HPE A5500SI-CMW520-R2222P11 Release Notes

Introduction

This document describes the features, restrictions and guidelines, open problems, and workarounds for version HPE A5500SI-CMW520-R2222P11. Before you use this version on a live network, back up the configuration and test the version to avoid software upgrade affecting your live network.

Figure 1 Network diagram

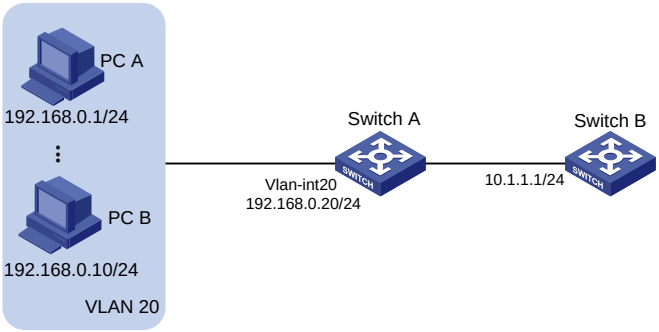
As shown in Figure 1, configure packet filtering on Switch A to meet the following requirements:

- Allow only packets from PC A to Switch B to pass through.
- Allow PC A and PC B to communicate at Layer 2.

- In versions before Release 2220P11, the configuration on Switch A is as follows:
